WATER QUALITY MEMORANDUM

Utah Coal Regulatory Program

SUBJECT: Fourth Quarter of 2012 Water Monitoring, Andalex Resources, Centennial Mine, C/007/0019, Task ID #4214

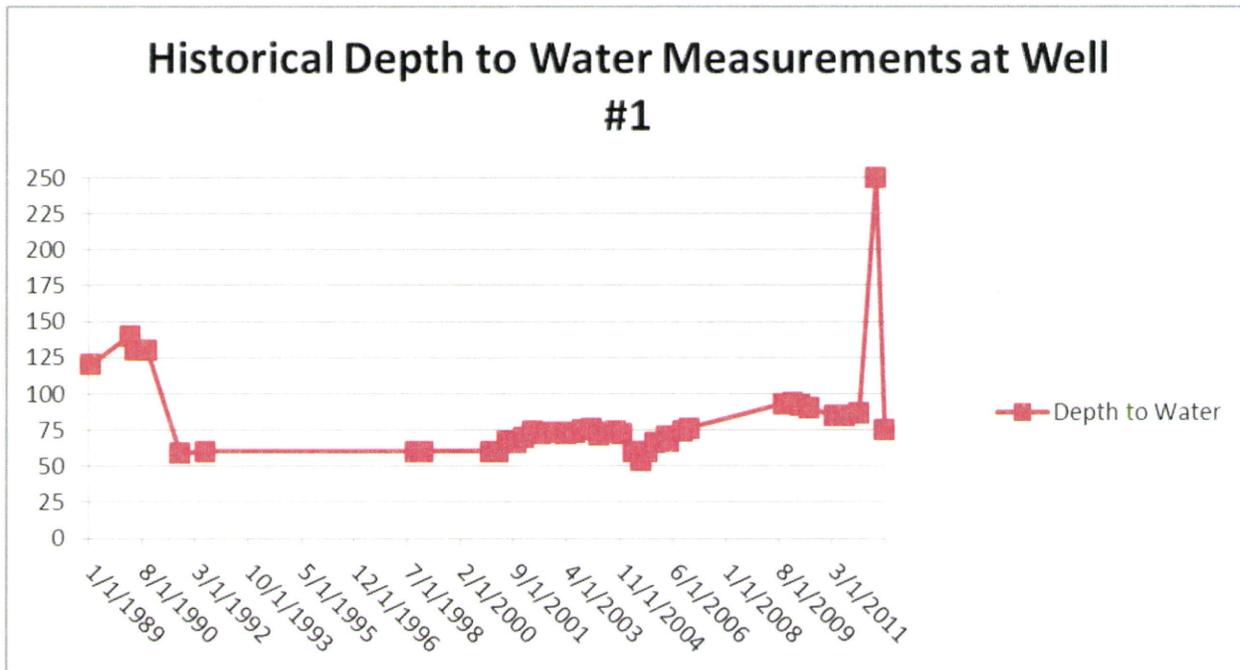
None. Depth to water levels measured averaged 75 feet, which appears to be consistent with data from previous year's seasonal data. The 250 reading from second quarter was an erroneous measurement.

No fourth quarter of 2012 data added to graph due to frozen pump.
